GOVERNMENT OF THE DISTRICT OF COLUMBIA
OFFICE OF PLANNING

MEMORANDUM

SUBJECT: Hearing Report on Zoning Commission Case Number 05-26 to Establish a Planned Unit Development on Property Known as 2950 Tilden Street, N.W. (Square 2234 Lot 800)

LOT 800 of square 2234 - TILDEN STREET, NW
Washington, DC

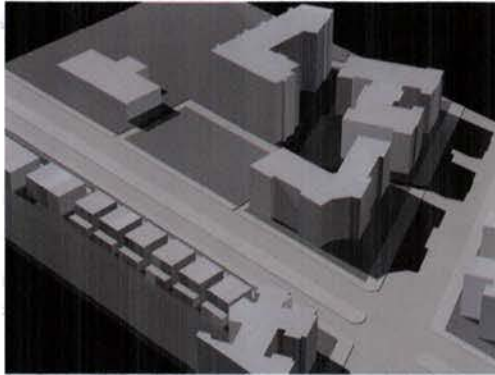
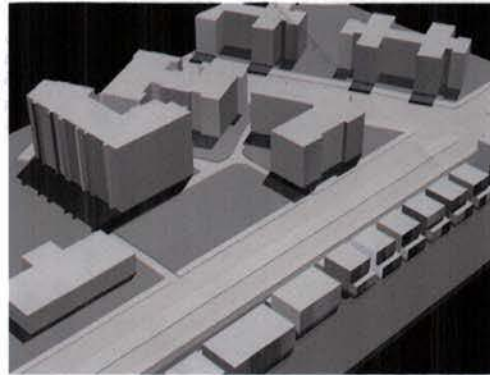
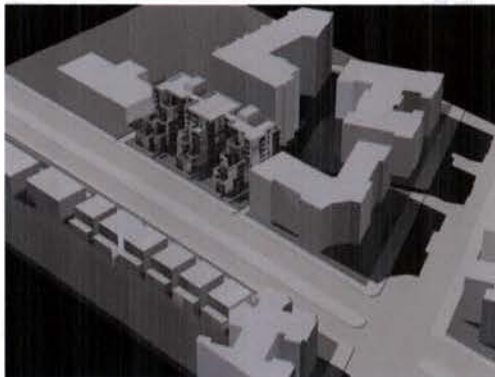
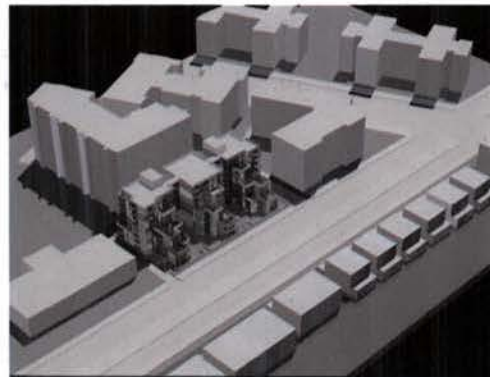
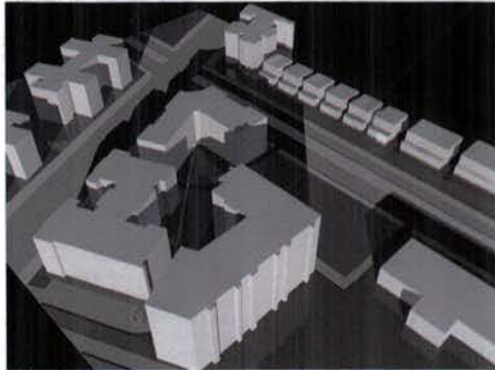
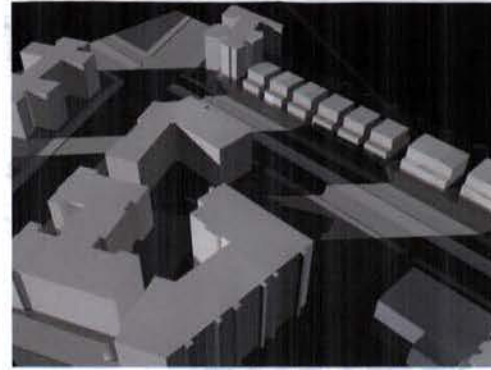
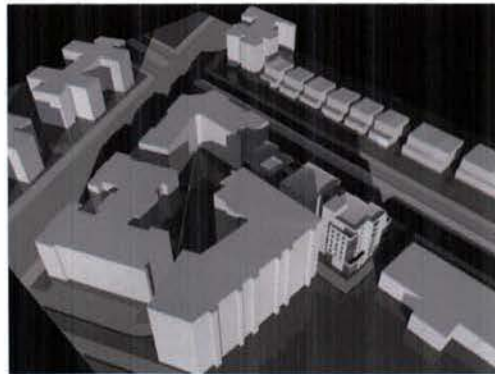
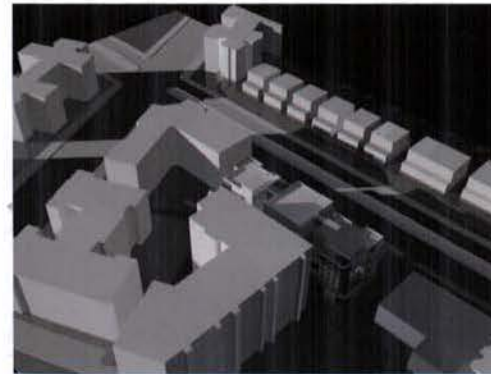
Based on the shadow study of a previous 9-story building proposal provided by the applicant (refer to Exhibit 3), the 6-story proposal would have minimum impact on the air and light available to neighboring properties. While OP supports additional density on this site, the current scale of the building continues to be a concern. The DDOT report will address issues related transportation circulation impacts, loading and deliveries. *The report is needed for OP to complete its assessment of this standard.*
